Addendum #01

Date: June 25, 2021

Project: Huntington Middle School Modernization and Addition

A492

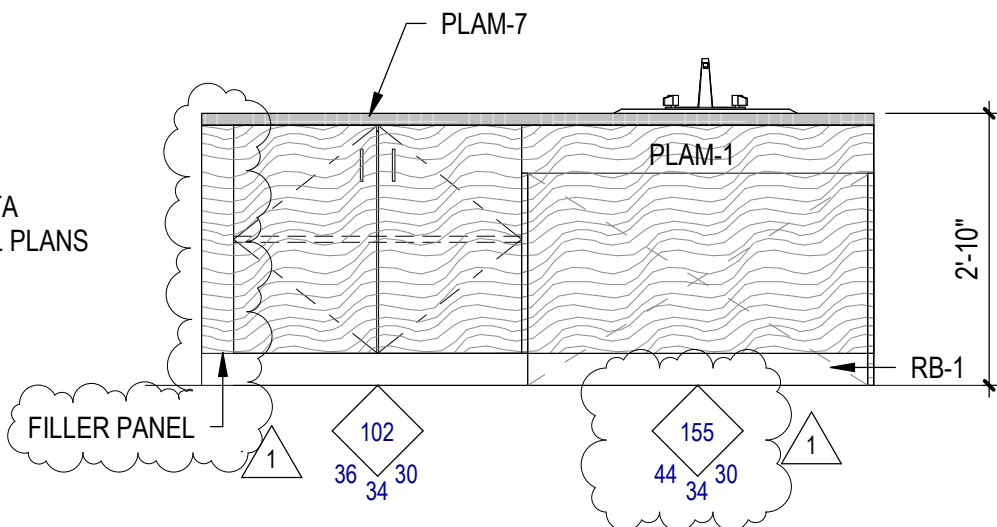
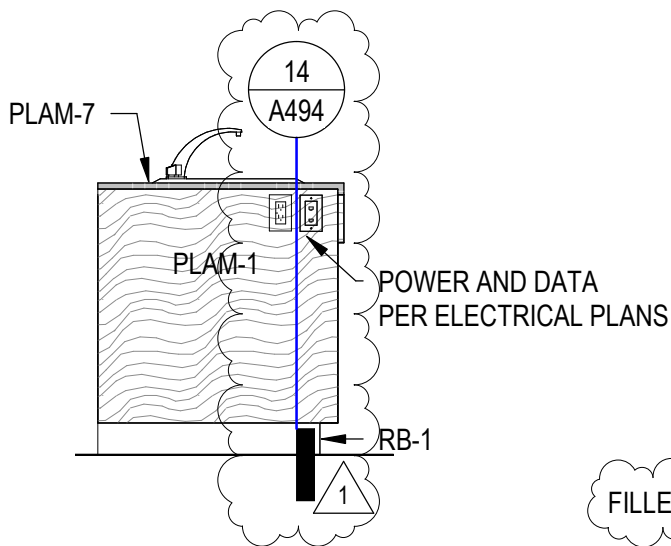
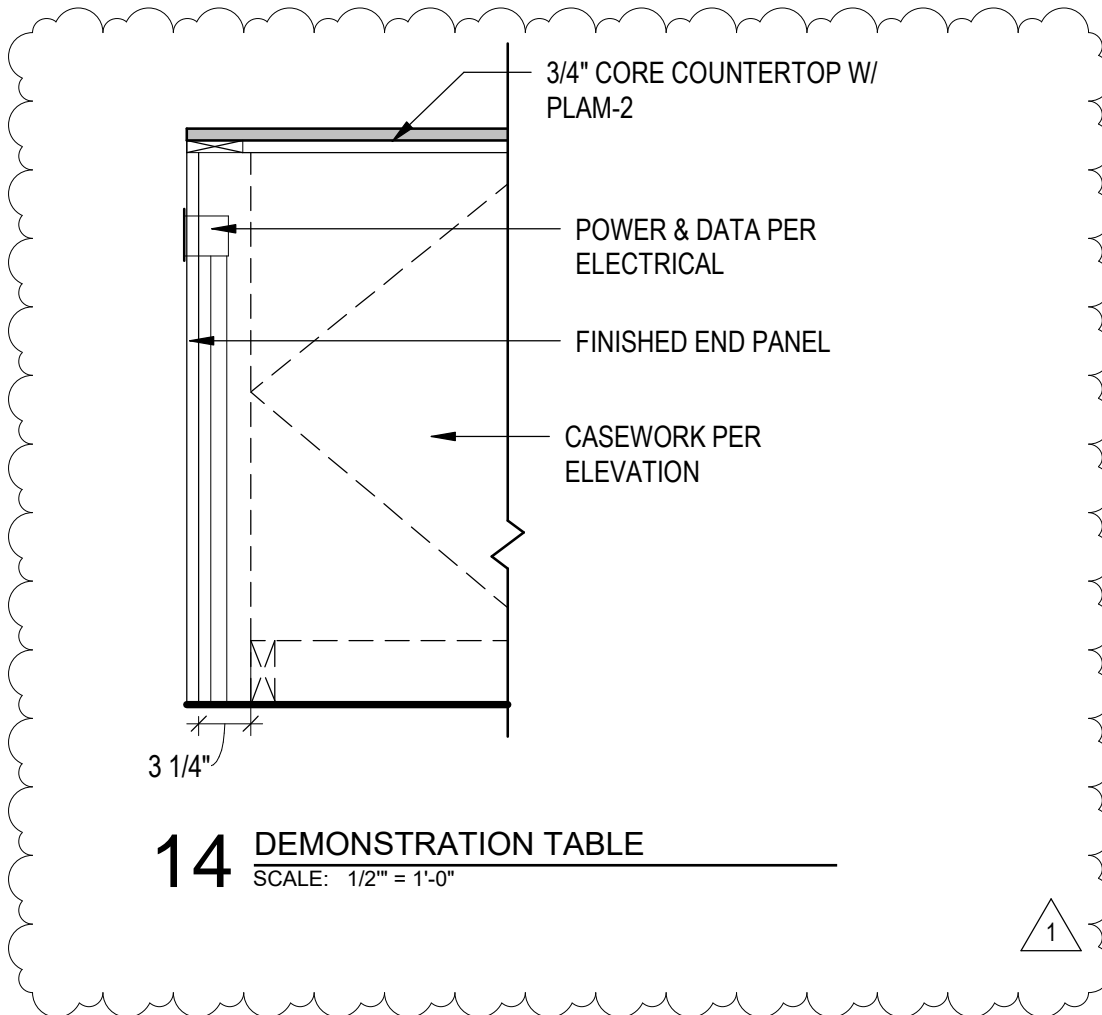
Item #A09 A492 – CASEWORK DETAILS
Add. #01 **Revise** 1E/A492 per attached **ADA 006**

DWG. #: **ADA-007**
JOB #: 21938
DRAWN BY: CF
DATE: 06/25/21
REF. DOC.: ADDENDUM 01

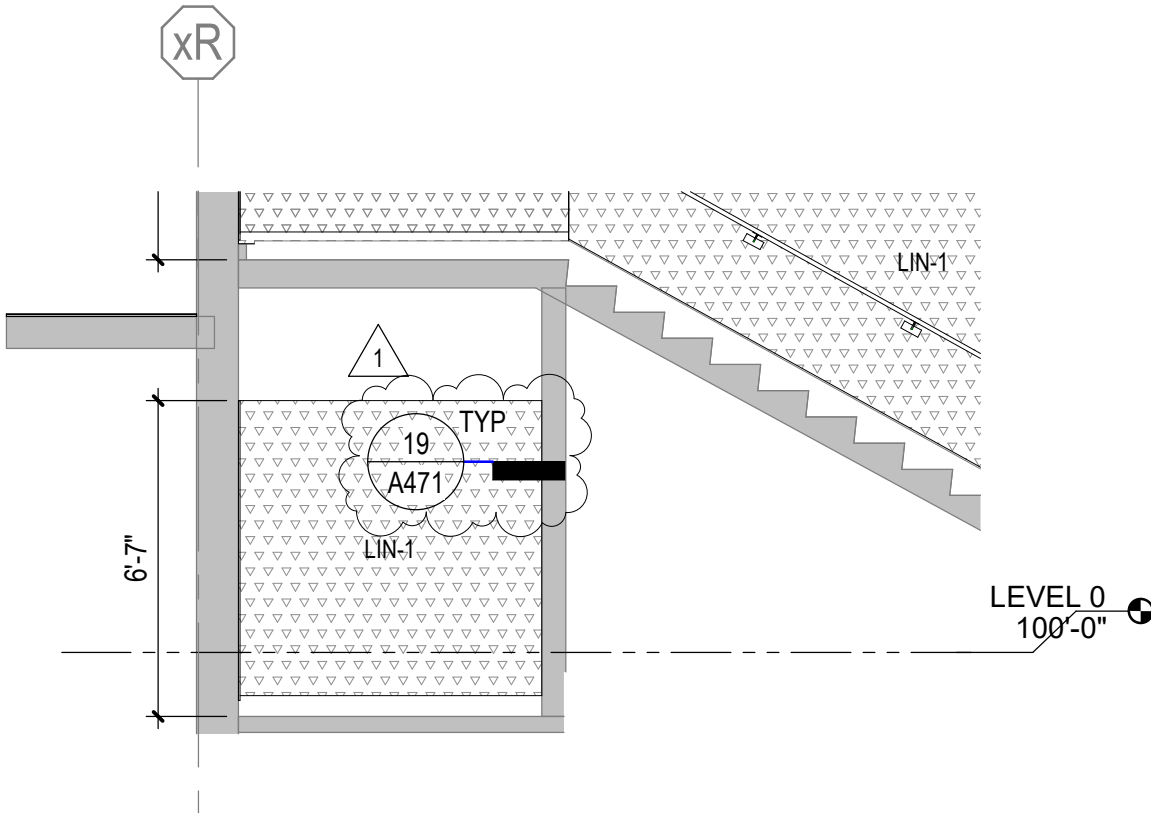
Item #A10 A494 – CASEWORK DETAILS
Add. #01 **Add** 14/A494 per attached **ADA 007**

Revise 16C/A494 per attached **ADA 007**

Revise 16D/A494 per attached **ADA 007**

DWG. #: **ADA-008**
JOB #: 21938
DRAWN BY: SQ
DATE: 06/25/21
REF. DOC.: ADDENDUM 01

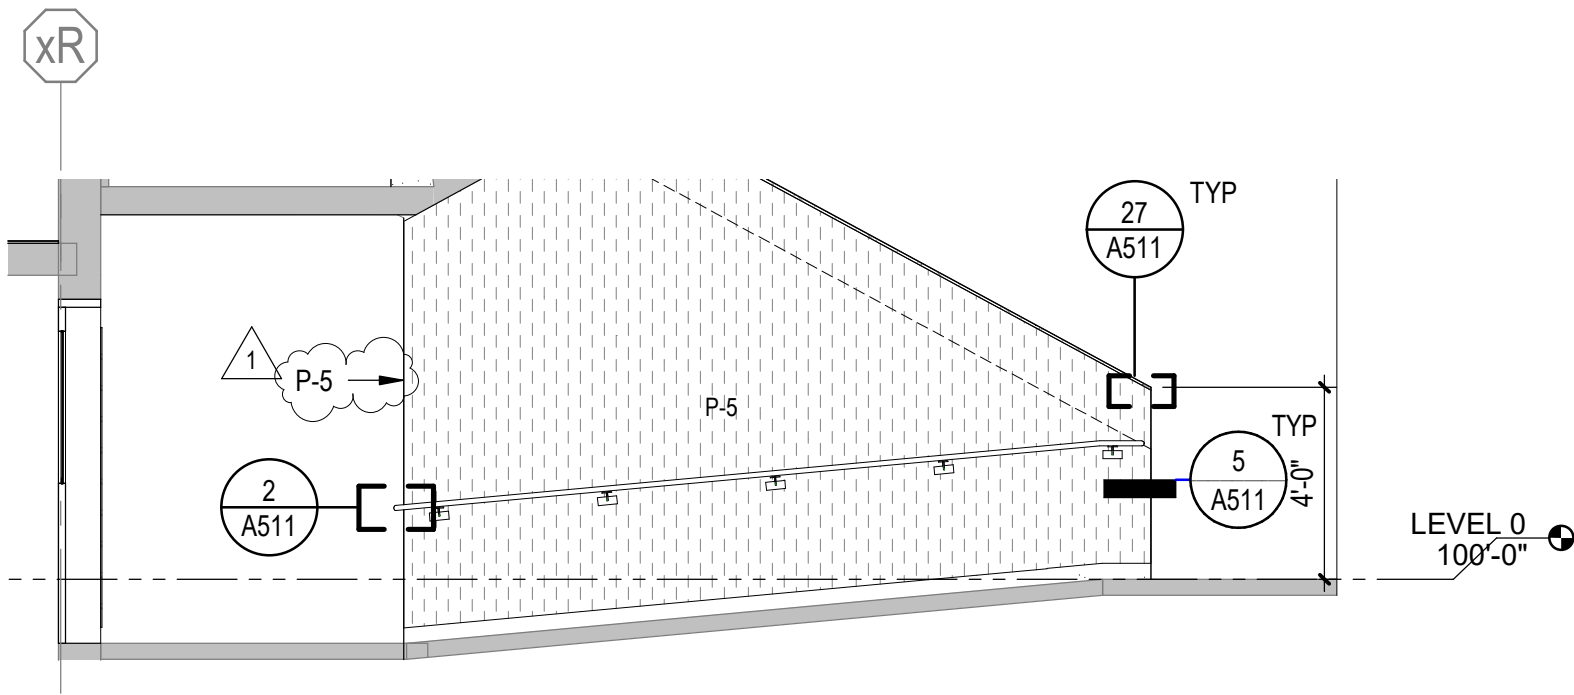
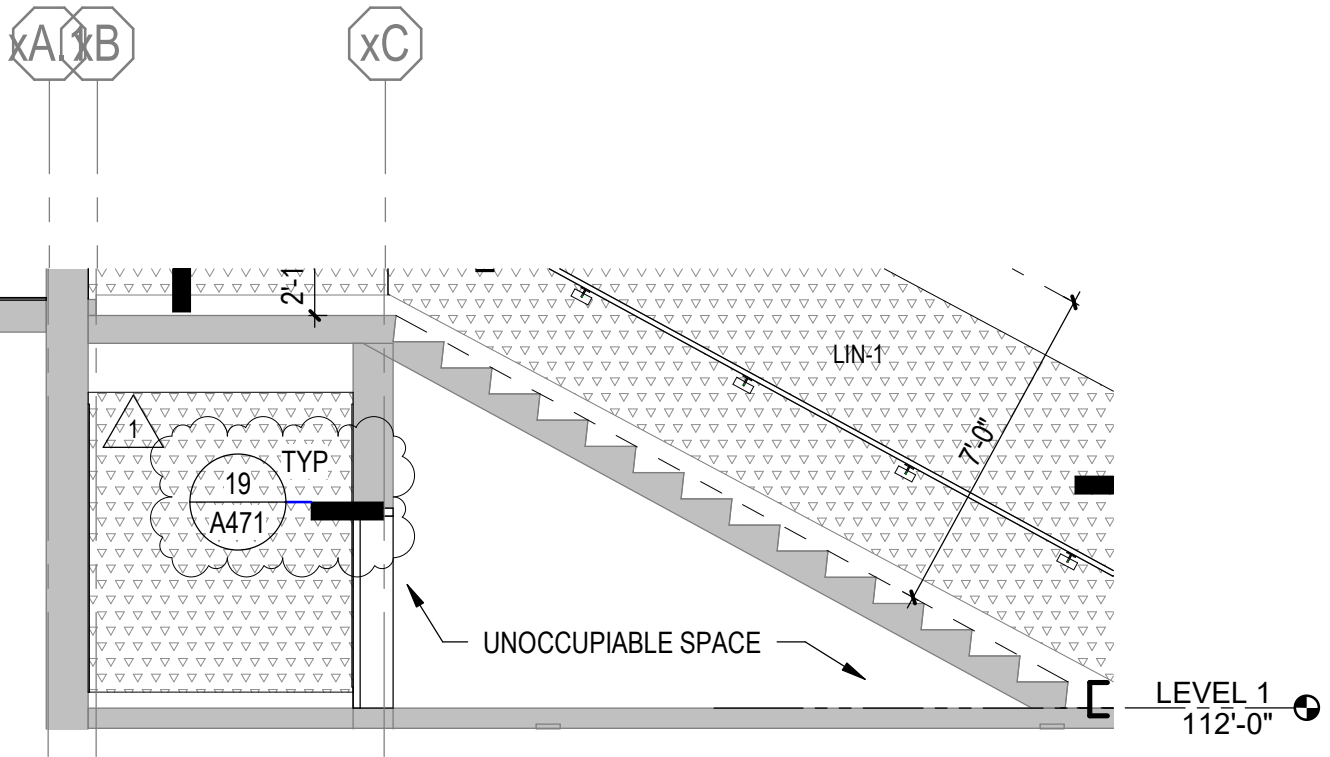
Item #A11 A502 – ENLARGED STAIR PLANS AND SECTIONS
Add. #01 **Revise** 6/A502 per attached **ADA 008**

Revise 7/A502 per attached **ADA 008**

DWG. #: **ADA-009**
JOB #: 21938
DRAWN BY: SQ
DATE: 06/25/21
REF. DOC.: ADDENDUM 01

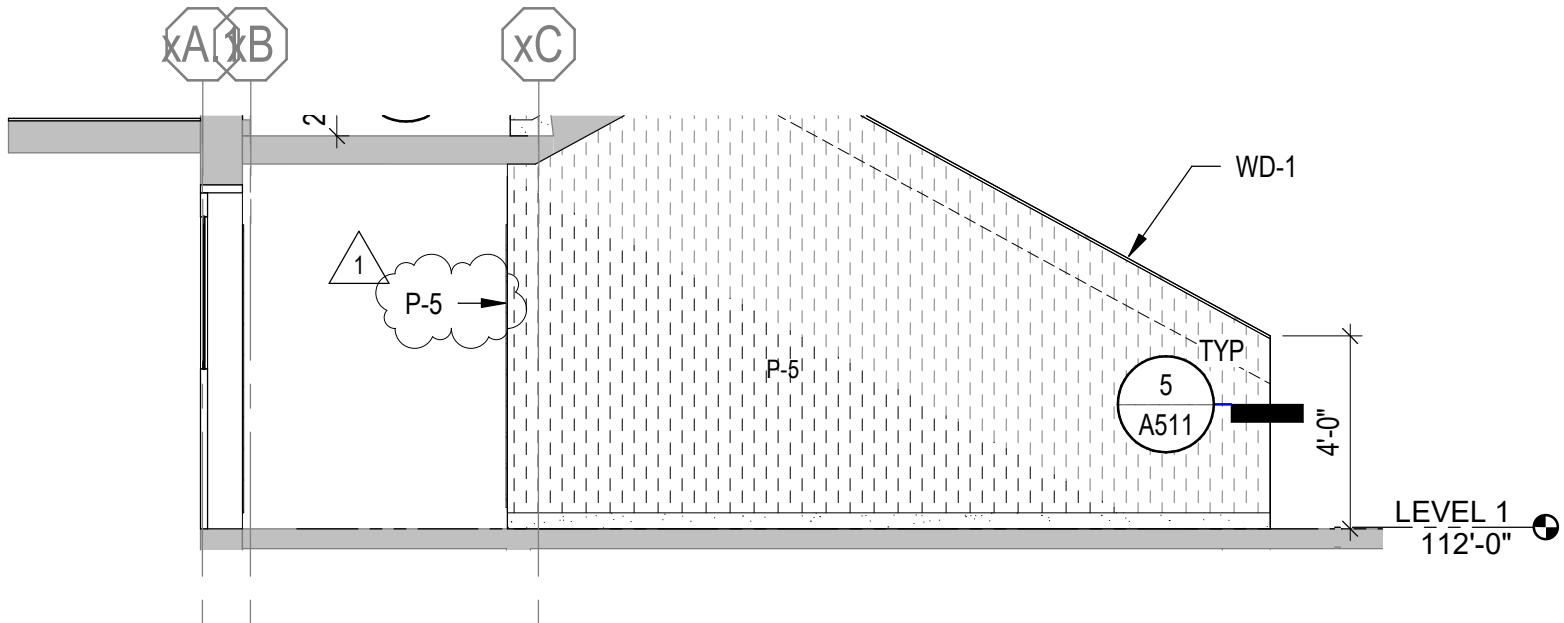
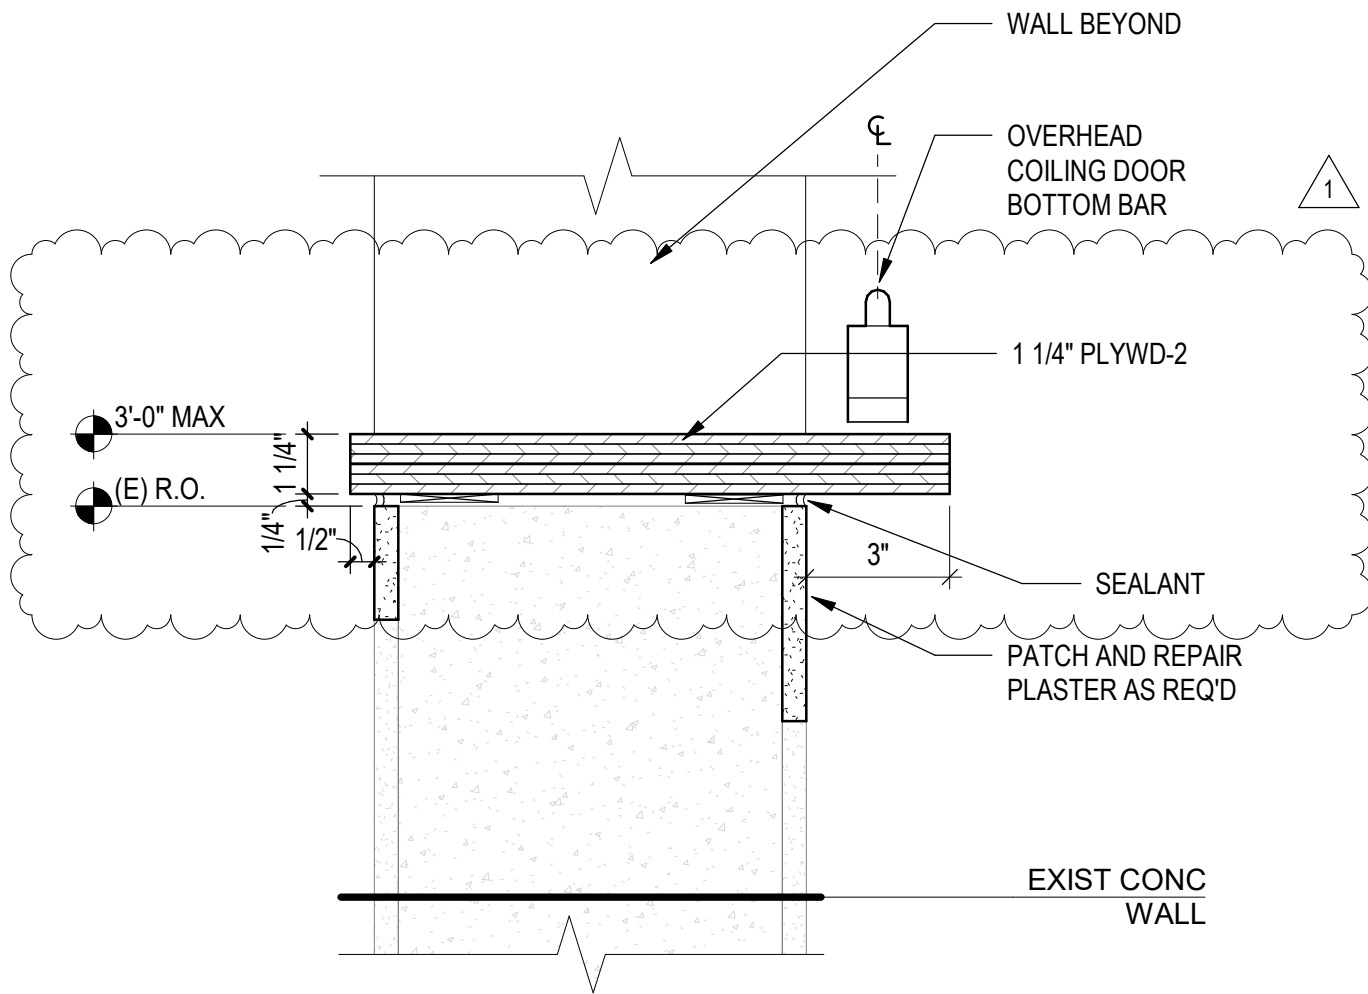
Item #A12 A504 – ENLARGED STAIR PLANS AND SECTIONS
Add. #01 **Revise** 3/A504 per attached **ADA 009**

Revise 6/A504 per attached **ADA 009**

20 COILING COUNTER DOOR SILL @ CONG
SCALE: 3" = 1'-0"

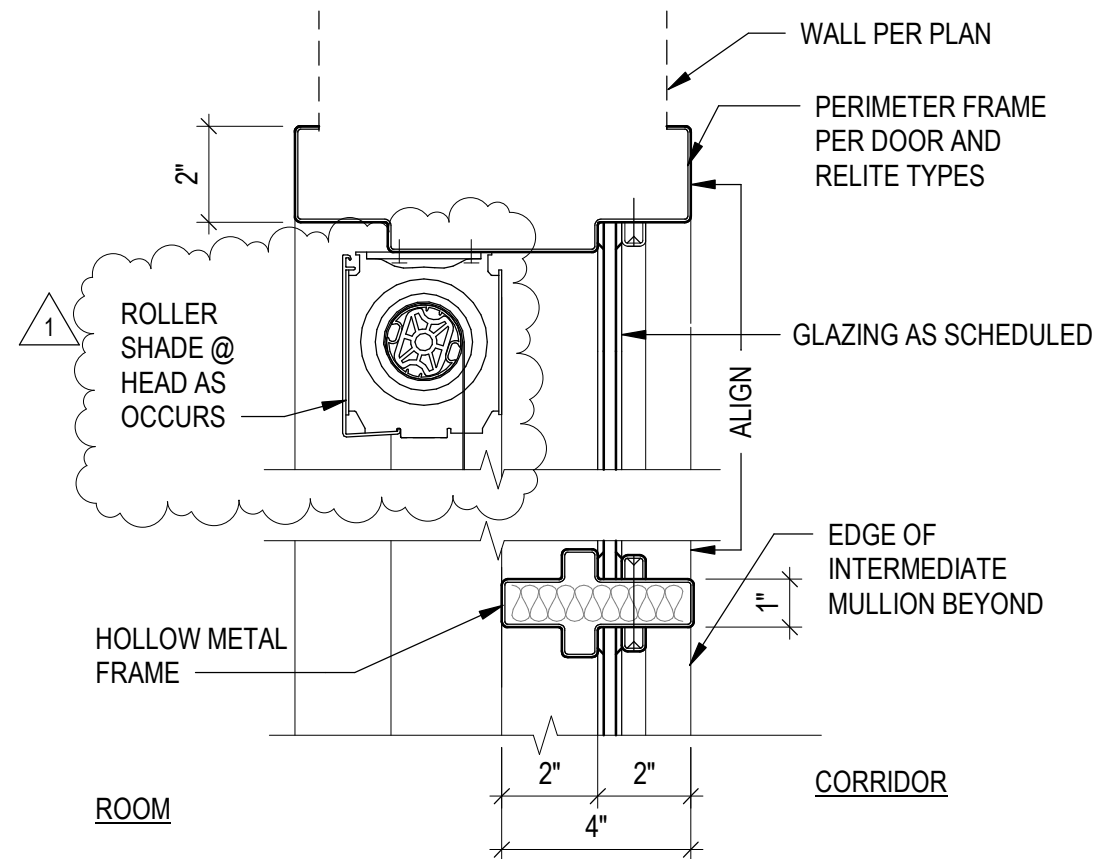
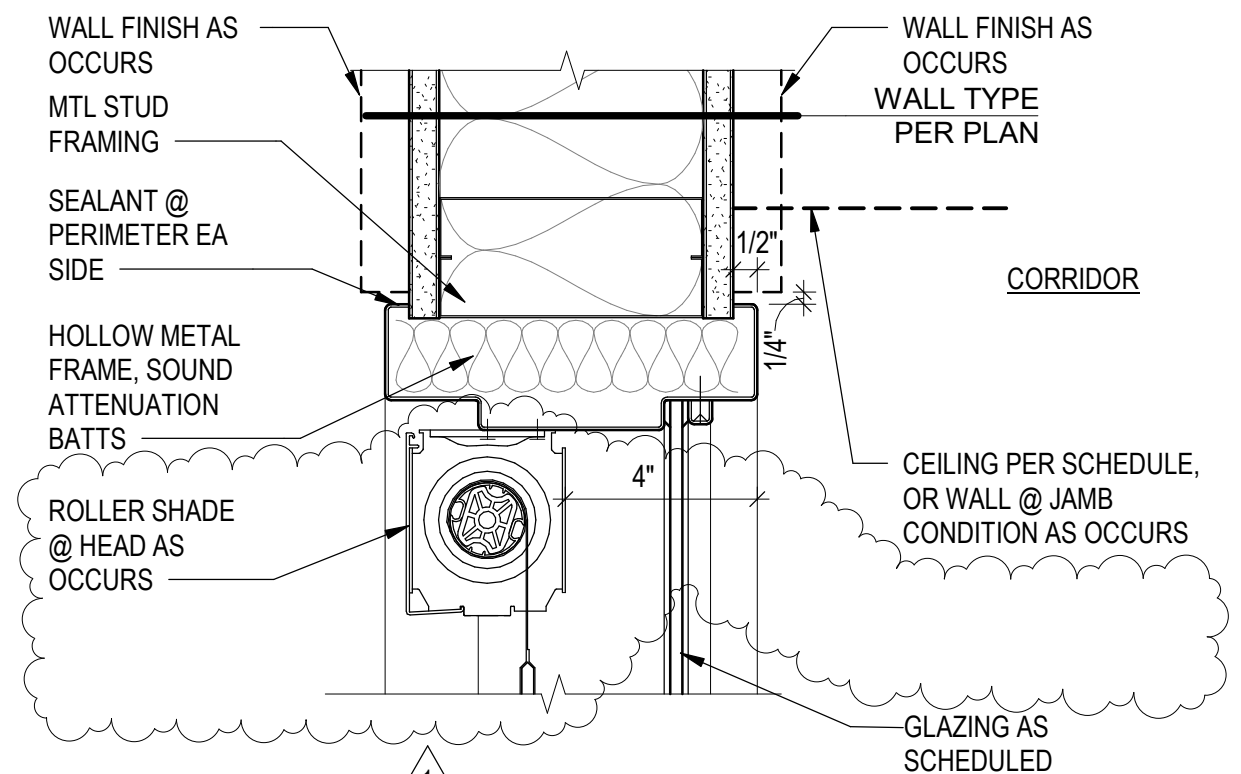
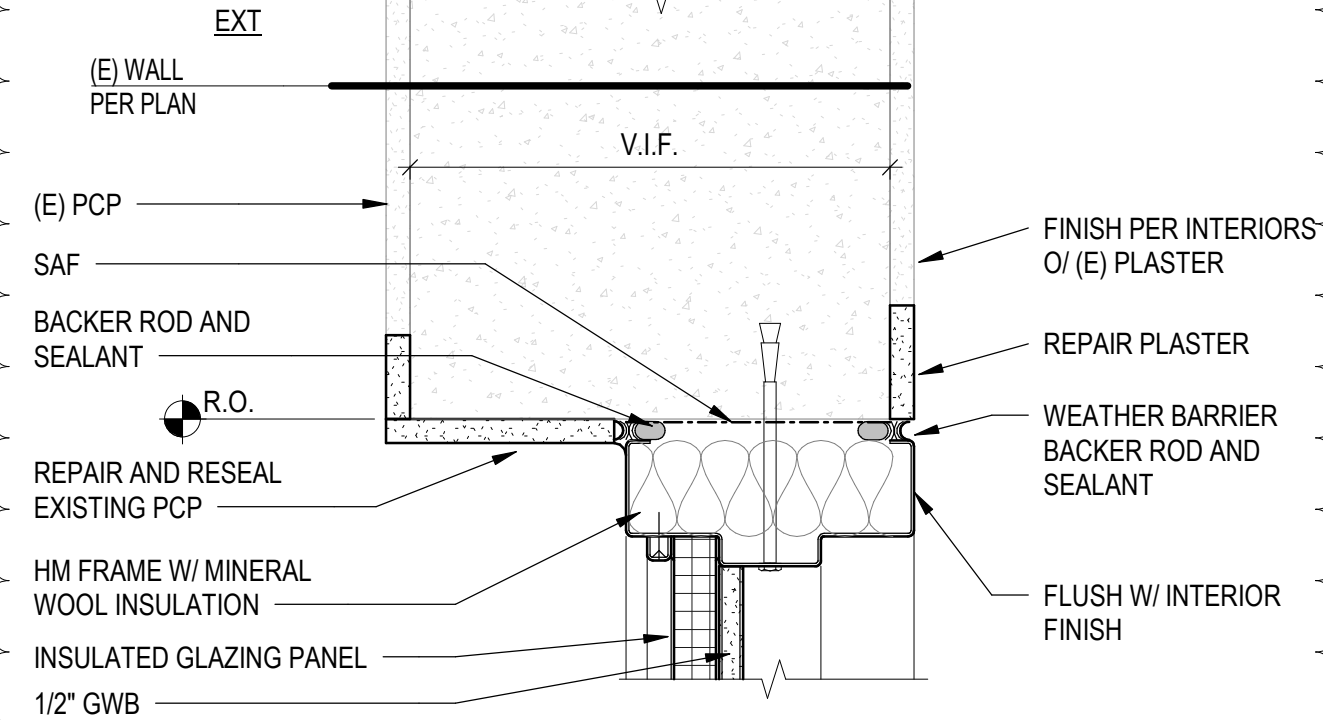
Revise detail 4/A611 per attached **ADA 010**

Revise detail 6/A611 per attached **ADA 010**

Revise detail 20/A611 per attached **ADA 010**
